## KIDDE RESIDENTIAL AND COMMERCIAL SERVICE BULLETIN #007

**SUBJECT:** Kidde 10 lb. Dry Chemical Fire Extinguishers with Black Zytel® Nylon Valves and Steel Cylinders

**DATE:** July 20, 2004

### Identifying the affected models

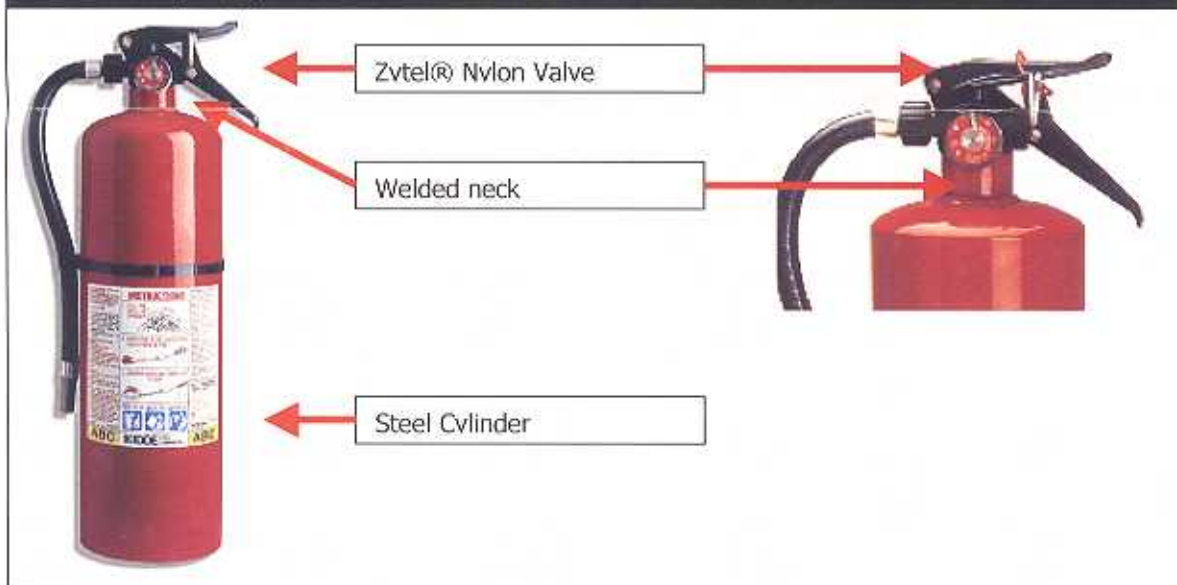
**Identification of Applicable Fire Extinguisher Models:** All Kidde 10 lb. dry chemical fire extinguisher models that utilize a black Zytel® nylon valve assembly and a welded steel neck collar cylinder and which were manufactured between 1991 and 2000 are covered by this bulletin. These models can be visually identified by comparing them to the images below.

**ONLY MODELS HAVING THE SAME TYPE OF WELDED TOP CYLINDER NECK COLLAR SHOWN ARE SUBJECT TO THIS BULLETIN. SUBJECT MODELS ALSO HAVE A TOTAL HEIGHT OF BETWEEN 20 TO 21 INCHES.**
